ADDENDUM

NO. 1

PROJECT NAME: Tomball ISD Intermediate School Replacement

ADDENDUM DATE: Tuesday, July 28, 2026

1 POWER PLAN - LEVEL 01 - AREA E
1/8" = 1'-0"

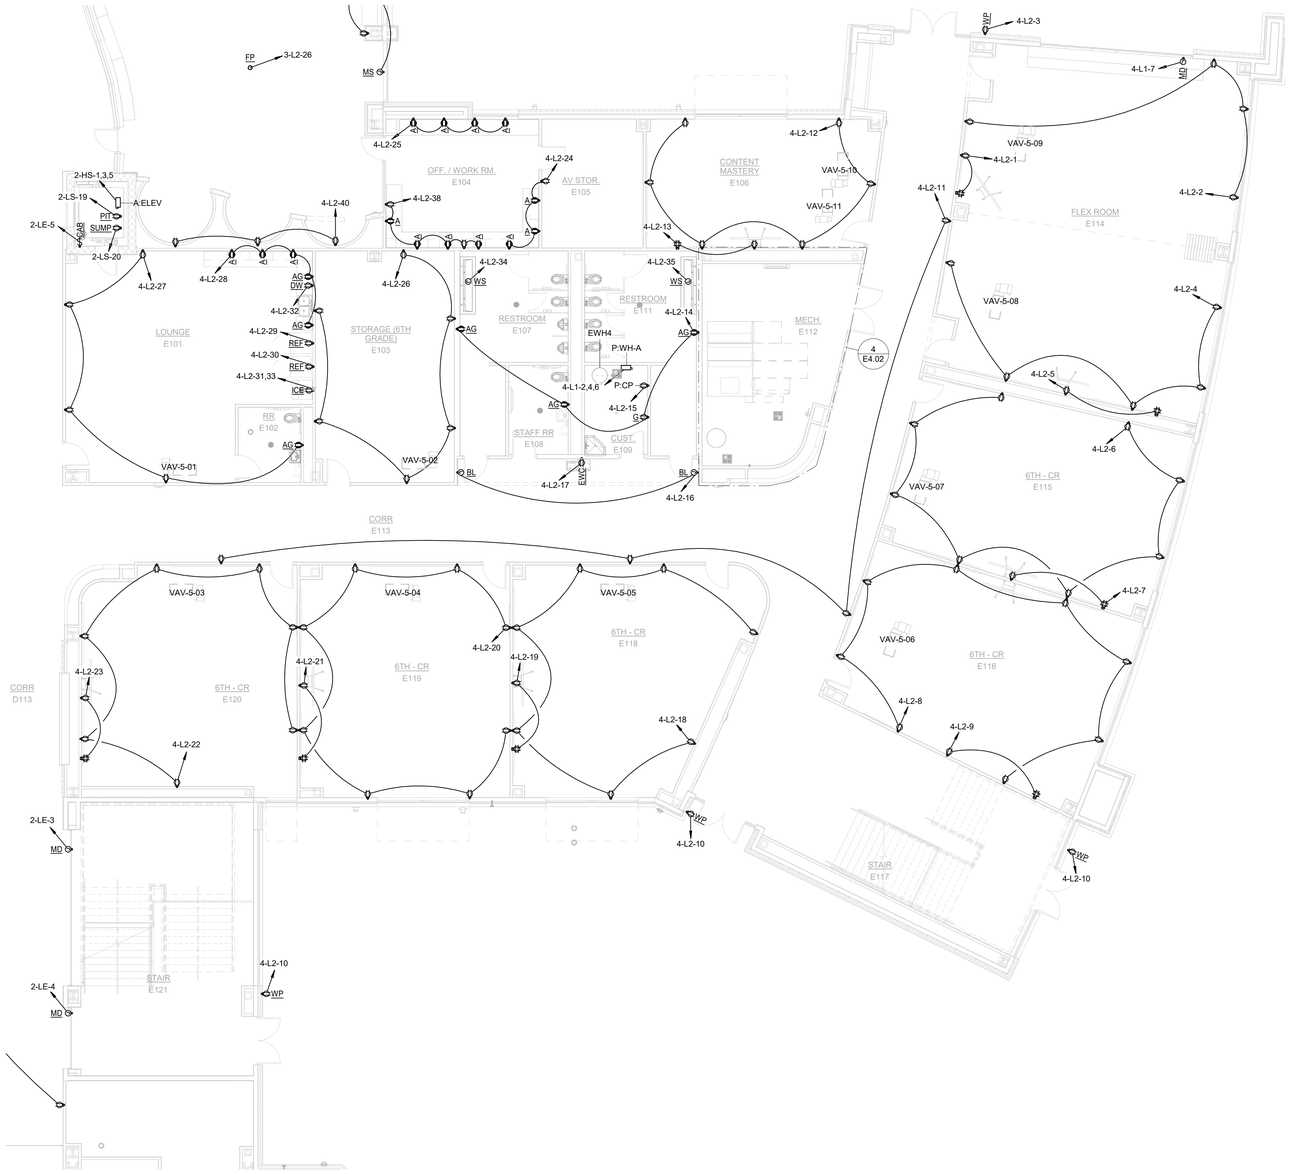
AD No 1, Elec. Item 4: To the Drawings, Sheet E2.1E, "POWER PLAN – LEVEL 01 – AREA E"

1 LIGHTING RCP - LEVEL 02 - AREA A
1/8" = 1'-0"

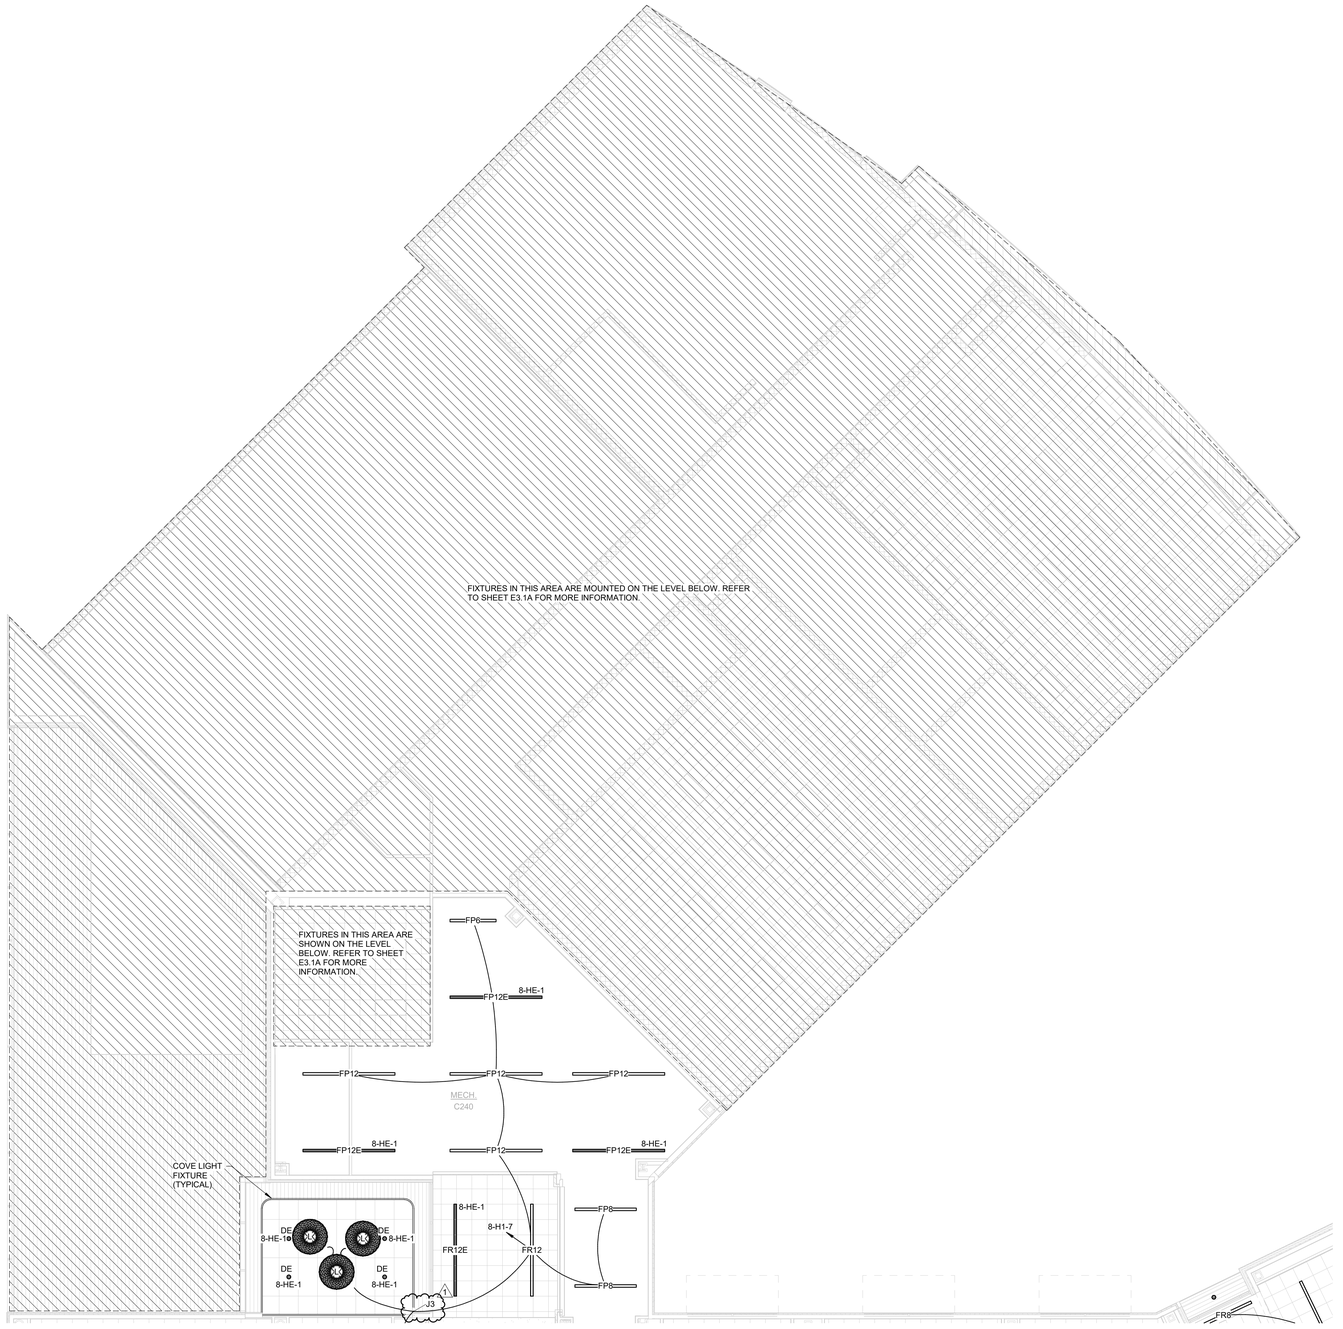
AD No 1, Elec. Item 11: To the Drawings, Sheet E3.2A, "LIGHTING RCP – LEVEL 02 – AREA A"

1 LIGHTING RCP - LEVEL 02 - AREA B
1/8" = 1'-0"

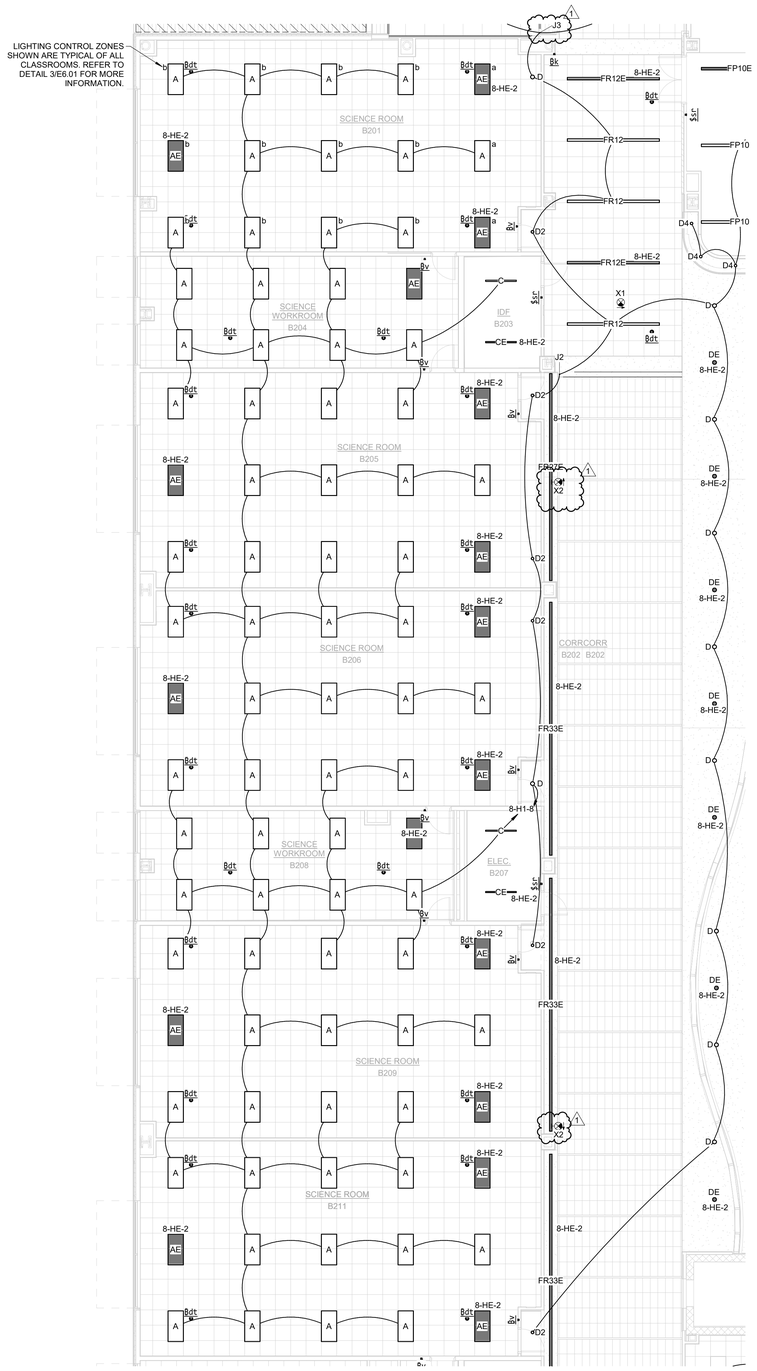
AD No 1, Elec. Item 12: To the Drawings, Sheet E3.2B, "LIGHTING RCP – LEVEL 02 – AREA B"

1 LIGHTING RCP - LEVEL 02 - AREA D
1/8" = 1'-0"

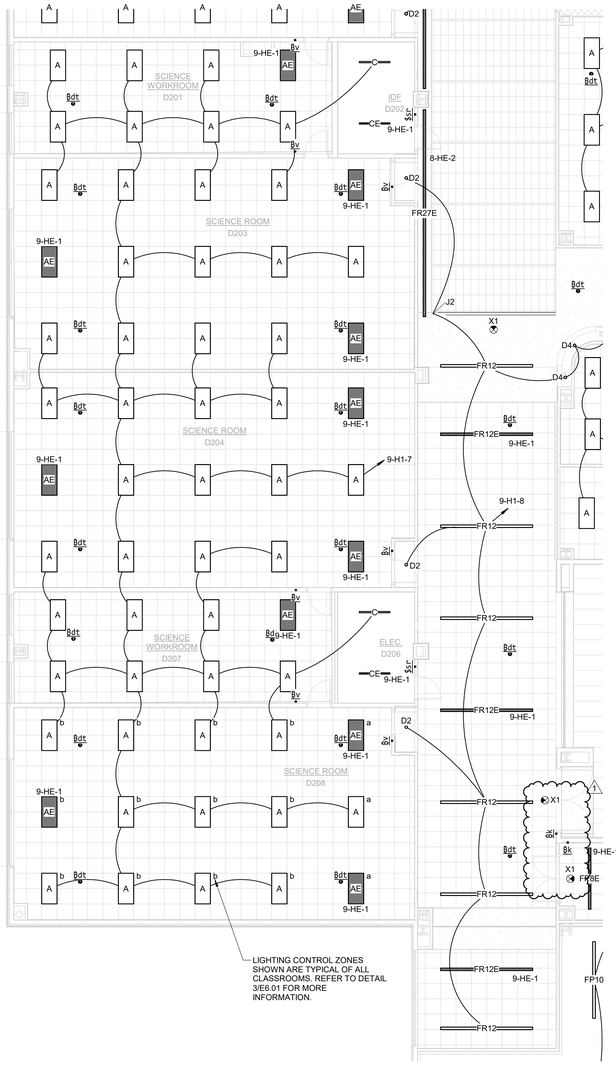
AD No 1, Elec. Item 13: To the Drawings, Sheet E3.2D, "LIGHTING RCP – LEVEL 02 – AREA D"
